**CITY OF DEXTER
PLANNING COMMISSION
REGULAR MEETING
MONDAY, AUGUST 3, 2015**

Re: Final Site Plan Review FSPR #2015-03 Dan Hoey Medical Office, revised plan dated 8-4-2015
Parcel #08-08-08-200-024

SUGGESTED MOTIONS –Dan Hoey Medical Office Building Final Site Plan Review

BEER GROTTO AREA & SEATING PLAN
 © COPYRIGHT 2014
The Beer Grotto
 8059 Main Street - Dexter, Michigan 48130

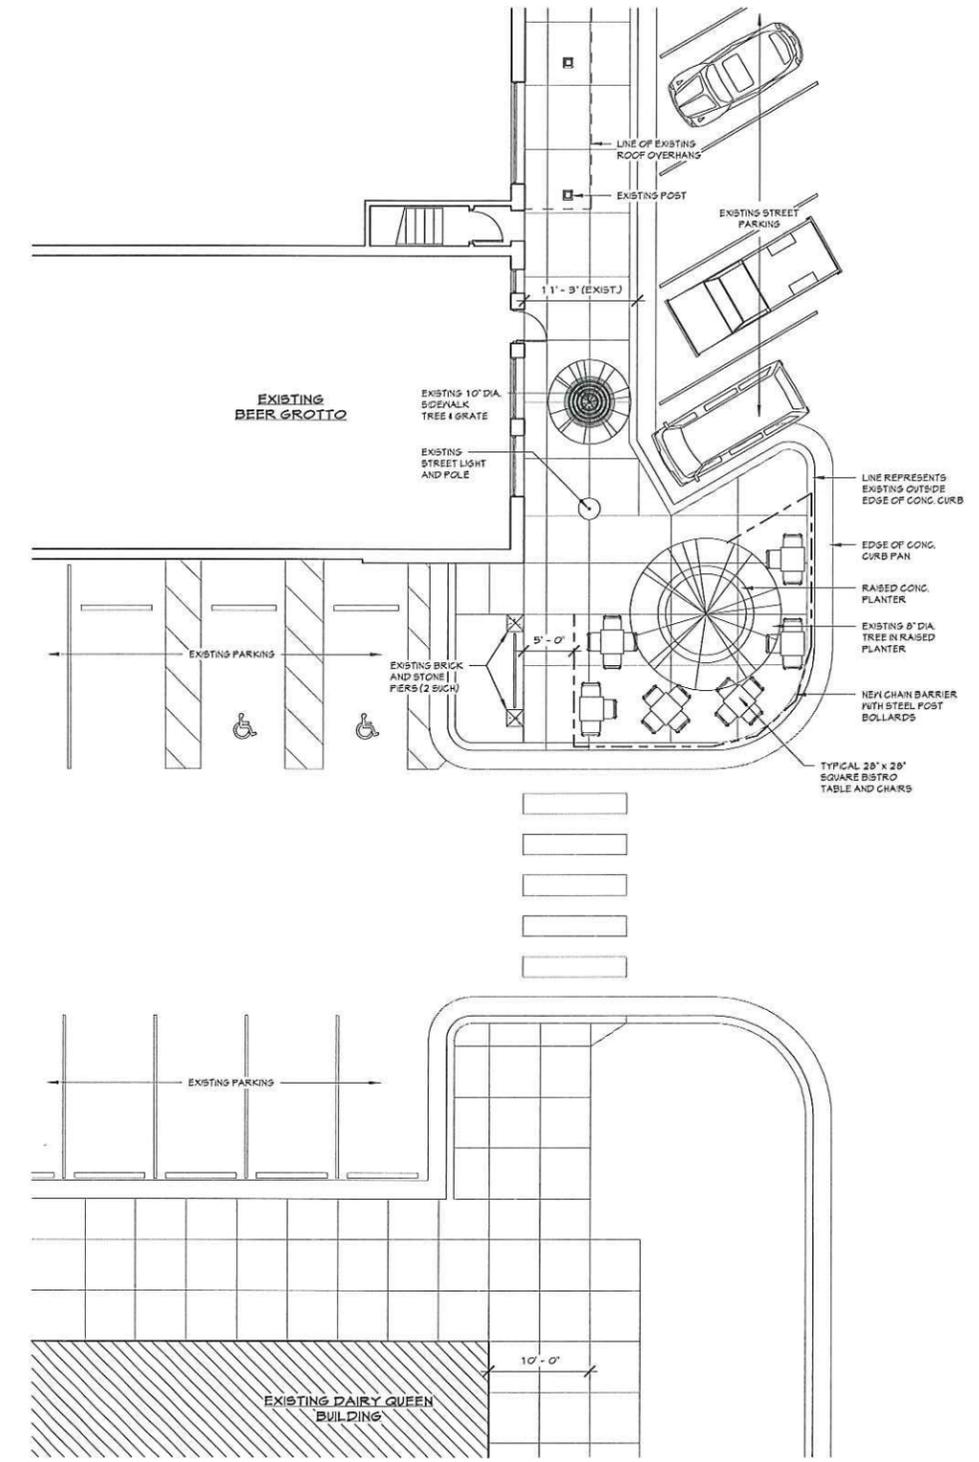
The applicant is proposing six (6) bistro style tables with chairs to accommodate 21 patrons. A 5-foot wide area between the building front and the proposed outdoor seating would provide unobstructed pedestrian access. A removable chain barrier with steel posts is proposed as required for establishments serving alcohol.

- a. *Pedestrian Circulation:* To allow for pedestrian circulation, a minimum of five feet of clear sidewalk along the street frontage, and leading to the entrance to the establishment shall be maintained free of any encumbrances. A minimum of ten feet of sidewalk width must be provided to accommodate outdoor seating, if outdoor seating is placed on the public sidewalk. The sidewalk in front of the Beer Grotto measures 11 feet 3 inches wide and expands to a width of 28 feet. A 5-foot wide area between the building front and the proposed outdoor seating would provide unobstructed pedestrian access.

- c. *Enclosure:* Planters, posts with ropes, or other removable enclosures are encouraged and shall be used as a way of defining the area occupied by the outdoor eating area. If liquor is served a removable enclosure is required. The State of Michigan Liquor Control Commission (LCC) requires that outdoor seating areas serving alcohol be enclosed. The applicant has provided information on the proposed enclosure. The proposed enclosure is typical for outdoor seating areas in the city.

- d. *Canopies and umbrellas:* Extended awnings, canopies, or large umbrellas shall be permitted and located to provide shade. Colors shall complement building colors. The applicant did not provide information regarding the type or color of umbrellas that may be used. If umbrellas are desired, the applicant must provide the required information. Staff notes the applicant will be required to provide examples of the umbrellas upon submittal of the outdoor seating application.

Plan View
Scale - 1" = 25'

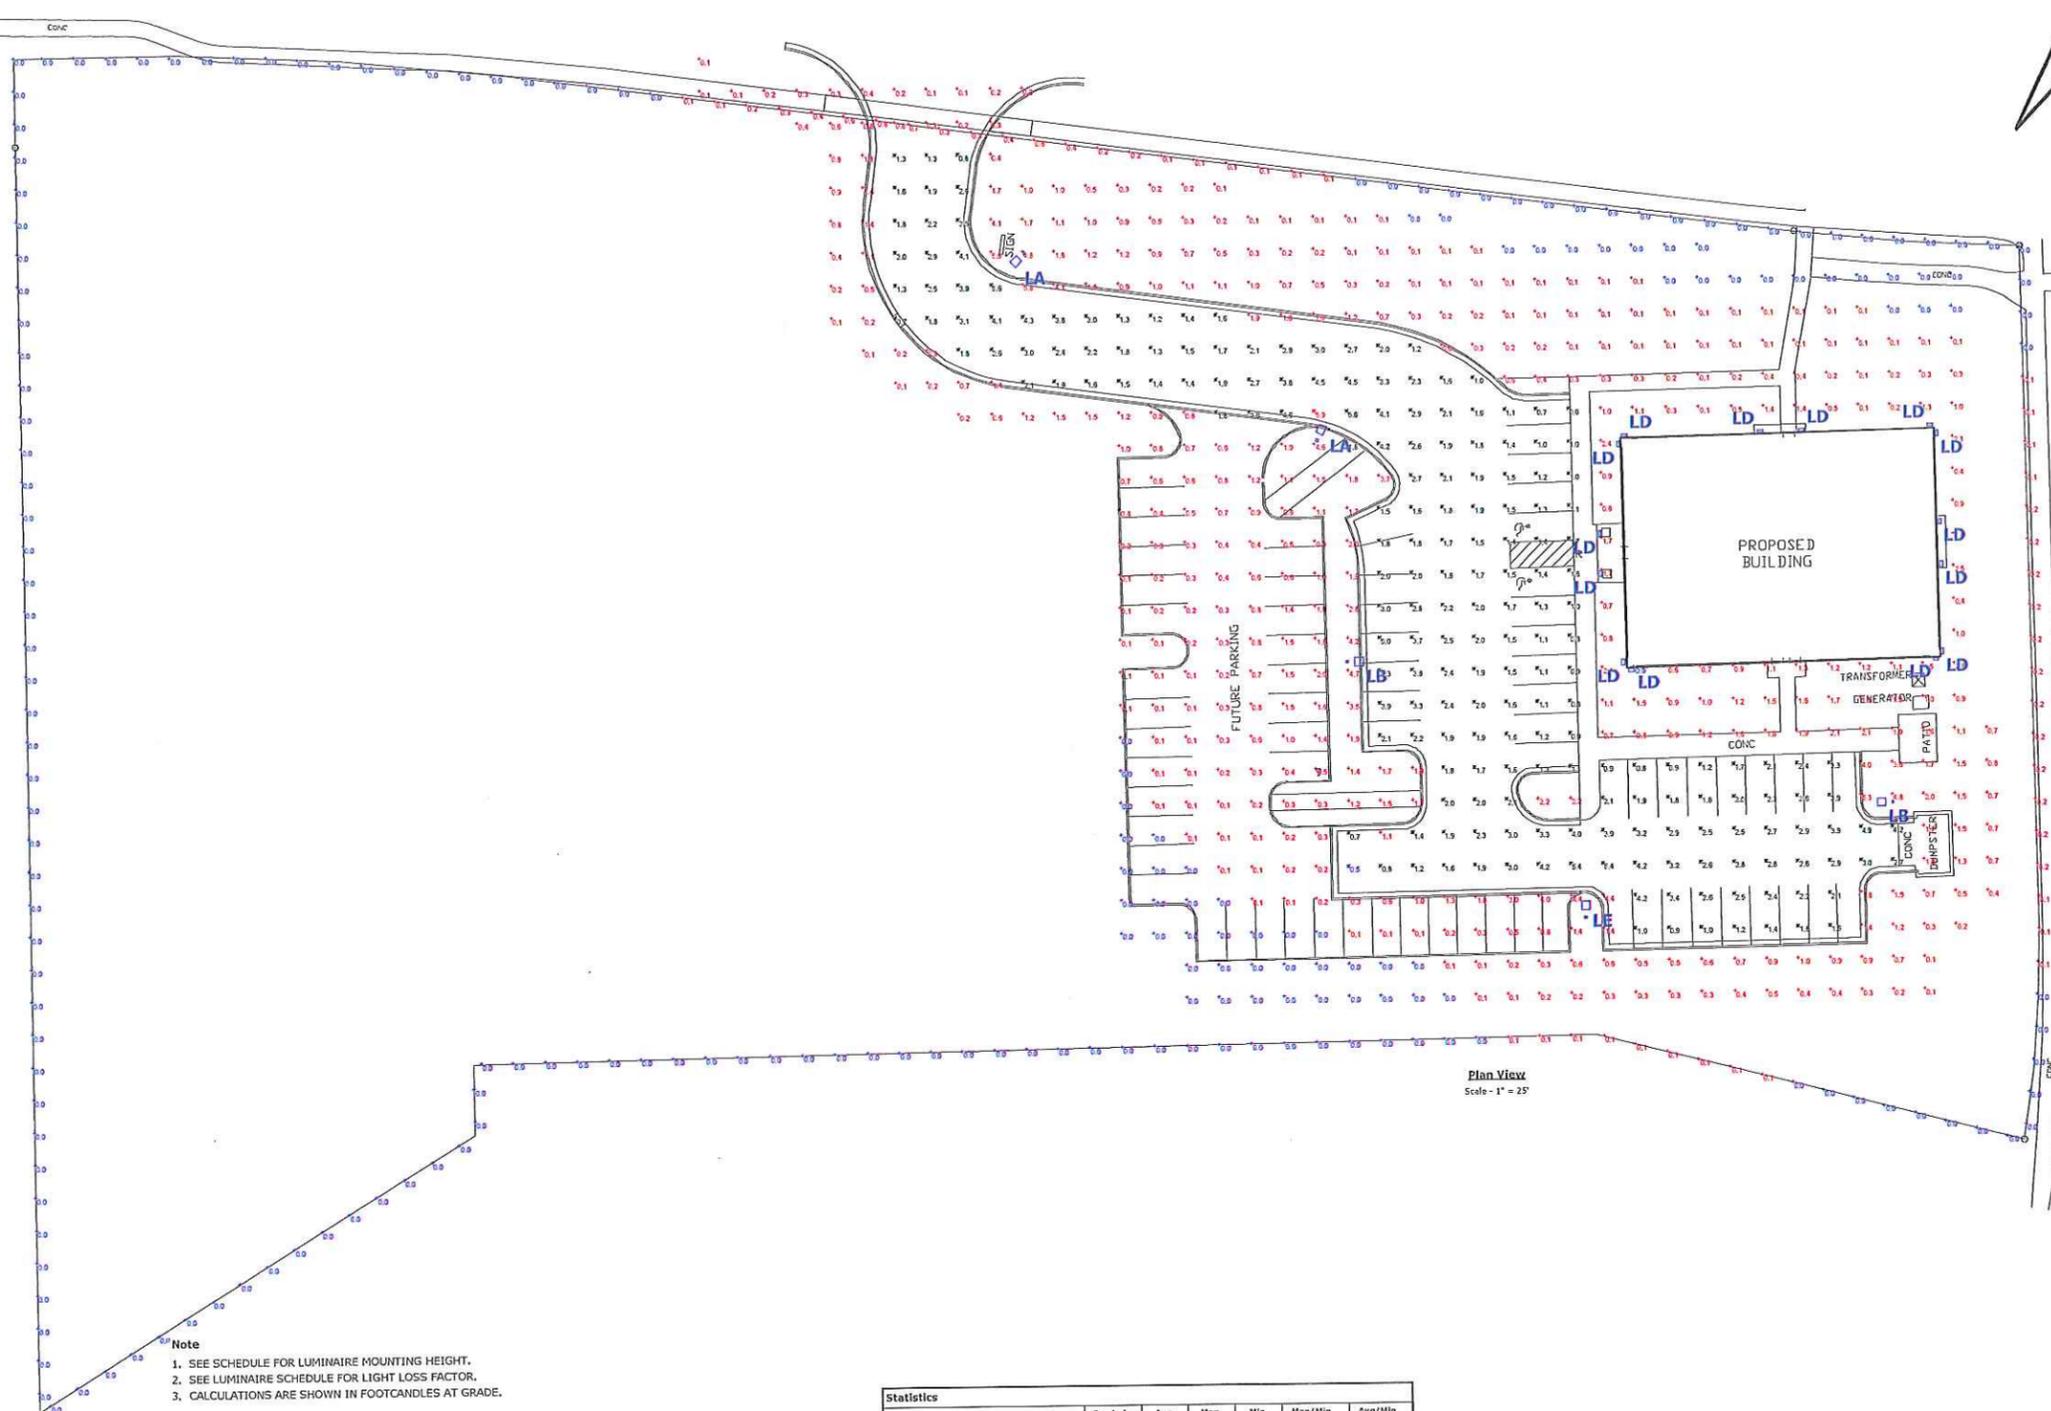
A lighting plan has been provided on Sheet 1 of 1 (Page 12). Five (5) 18-foot tall pole-mounted fixtures and 14 wall-mounted fixtures are shown on the lighting plan. Detail of the proposed pole-mounted fixtures demonstrates they are downward directed, fully shielded fixtures.

We note decorative light fixtures are shown on all building elevations (Sheet A 4.1). These fixtures have been included on the photometrics presented on Sheet 1 of 1. Detail of the wall-mounted fixtures has been provided; however, Section 3.19 E. (3) requires *for all non-residential uses, full-cut-off shades are required for light sources so as to direct the light onto the site and away from adjoining properties. The light sources shall be recessed into the fixture so as not to be visible from off site. Building and pole mounted fixtures shall be parallel to the ground.*

The applicant has not provided an alternative wall-mounted fixture that is downward directed. They have added a note to Sheet 1 of 1 that states: *All building-mounted fixtures (except designated security fixtures) to be installed on programmable timer switch. Fixtures to be turned off during non-operational hours.* This however, does not meet the requirement of Section 3.19 E. (3) as noted above.

- D. Decorative Building Mounted Lights. The applicant is proposing an architecturally decorative wall mounted fixture for all elevations of the building. The planning consultant correctly identified that the zoning ordinance requires 1) all non-residential uses to have full-cut-off shades for lighting sources, 2) light must be directed downward and away from adjoining properties, and 3) building mounted fixtures shall be parallel to the ground. Staff would like to note that the site is subject to the standards of the ARC Dexter-Ann Arbor Road Corridor Overlay District, which requires that site elements, including lighting be coordinated and compatible with the building design and harmonious with the intended character of the District. The proposed fixtures would meet the requirements of the ARC District.

SOUTH ELEVATION
SCALE: 1/8" = 1'-0"
3
A4.1

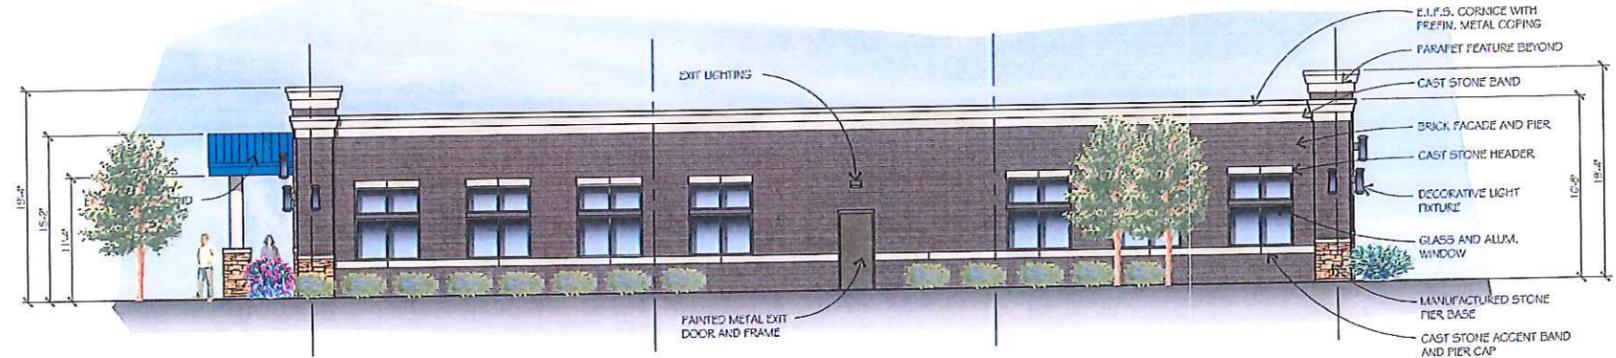
Transformer and generator location is depicted along the eastern building elevation which will be visible from Lexington Drive. Section 15(B).02 D. 7. requires all mechanical equipment be screened from public view. This includes roof-mounted equipment as well. See the landscaping section above with regard to the transformer and generator screening. The applicant has added a note to Sheet A4.1 stating: *rooftop mechanical units will be screened as required. Exact unit sizes and locations are subject to final engineering.*

Overall, the proposed exterior materials meet the 80% requirement (Section 15(B).02 D. 8. as demonstrated on the tables provided for each elevation on Sheet A4.1. We note EIFS is only allowed as an accent and does not exceed 5% of the total exterior building materials to be used on any elevation.
